Thank you for providing Citizens for a Clean Wausau (CCW) with the opportunity to submit comments on the Site Investigation Work Plans (SIWPs) for both 1300 Cleveland Avenue and the Former CN/WCL Railroad Track in Wausau, portions of which reside in very close proximity to one another.

## COMMENTS RELEVANT TO BOTH THE GEI SIWP AND ARCADIS SIWP

# COMMENTS ON THE GEI SITE INVESTIGATION WORK PLAN FOR 1300 CLEVELAND AVENUE

# COMMENTS ON ARCADIS SITE INVESTIGATION WORK PLAN FOR THE FORMER CN/WCL RAILROAD TRACK

Figure 2.1 - 3M Wausau Maximum Plan for Locomotive Rail and Storage Property

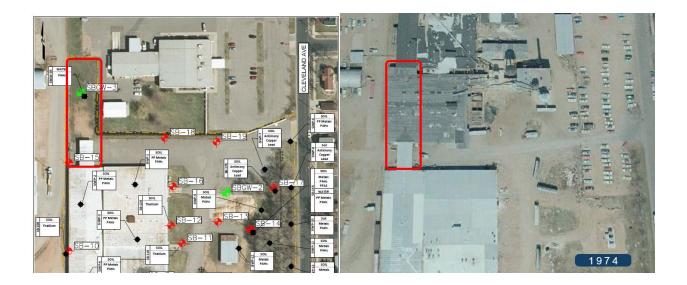
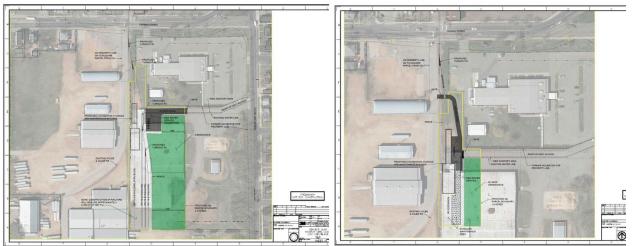
# Comment #2: We believe that sampling to date and the proposed future sampling in the GEI SIWP are insufficient to adequately define soil contamination in the northwest area of the site.

Sampling and proposed sampling in the northwest corner of the site are extremely limited, especially given 1) it is one of the few areas on the property where there had historically been a

manufacturing structure present and 2) should zoning and land use change in the future (e.g., 3M's proposal for rail operations), there is an extremely high chance of soil disturbance and disruption. Therefore, we feel that this portion of the property should undergo – at the very least – an equal level of sampling and investigation as the rest of the property, particularly in light of the bis(2-ethylhexyl) phthalate recently identified in nearby soil on the adjacent property – a phthalate with strong, documented associations with the lacquer/varnish products used by Connor Forest Industries.
